DEVELOPMENT ASSESSMENT REPORT

DA/1282/2010

Proposal: Industry – Asphalt Plant
Address: 11, 15 and 18 Billbrooke Close, Cameron Park
Lots 317, 318 and 319 DP1089554
Applicant: Parsons Brinckerhoff
Owner: Bitupave Limited
Consent Authority: Joint Regional Planning Panel
Lodged: 3 August 2010
Value: \$10 million
Submissions: 120 submissions, three petitions

Report on Asphalt Plant DA 1282/2010 Environmental Impact Statement Review

Figure 0-1 Annual Wind Rose for Tomago

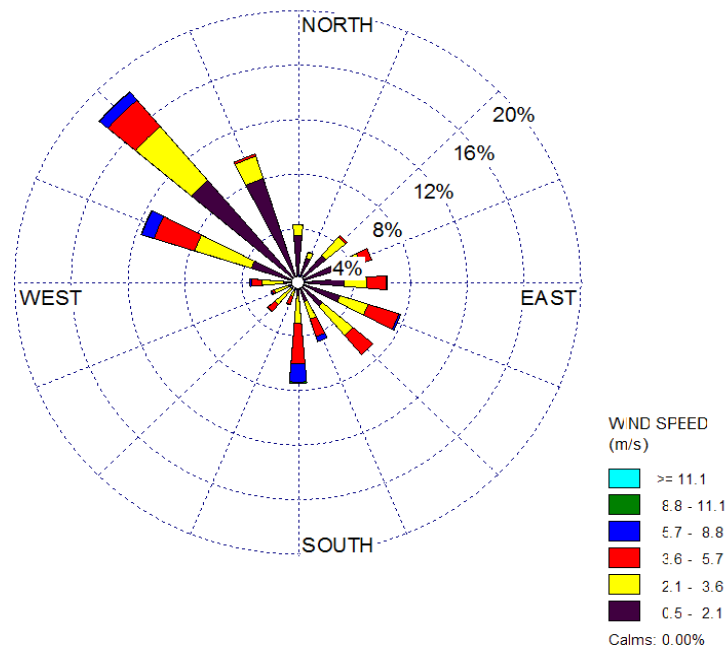
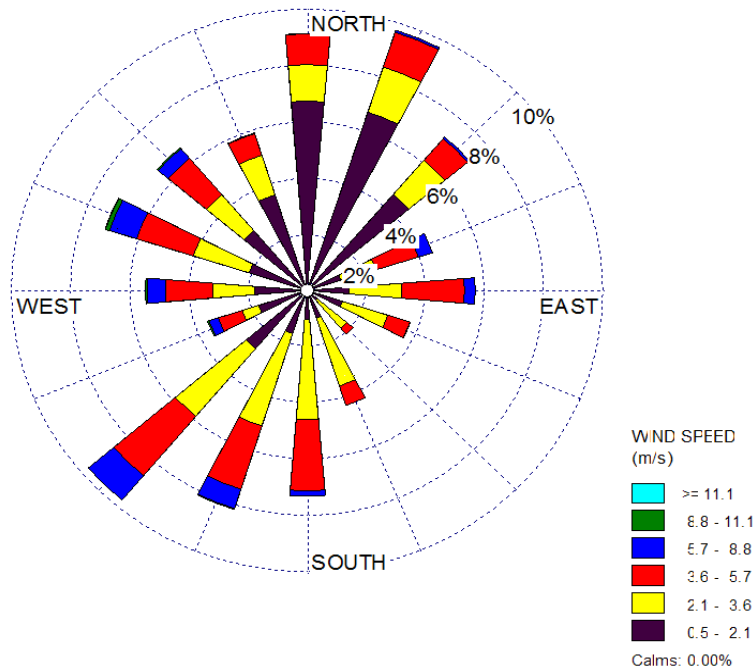
The reduced incidence of slower, and indeed calm, winds being generated by the TAPM model for such an inland site is alarming. No statistics on average wind speeds are given. An incidence of just 1% of winds 0.5 m/s or less is contentious for a site some 20 kilometres inland with considerable sheltering (Great Dividing Ranges) from the winter westerlies. Even the coastal NNSS site has 2% calms during the afternoons on an annual basis. No information is given on the TAPM version used. The latest version of TAPM V4 has a known correction to increase light wind preference from that given in TAPM V3: "TAPM tends to under predict calm conditions and over predict the frequency of high wind speeds." [Kaniyal and Mackenzie, 2008, p.4, http://www.acoustics.asn.au/conference_proceedings/AAS2008/papers/p29.pdf].

Note that as shown in Figure 0-2, for actual wind data recorded near Cameron Park, there are less than 1% of winds above 8.8 m/s inland of Newcastle and on the coastal side of the Sugarloaf Range. This does not compare with the high frequency of winds above 11.1 m/s (cyan rose petal in Appendix B of the AQIA) which was generated by TAPM.
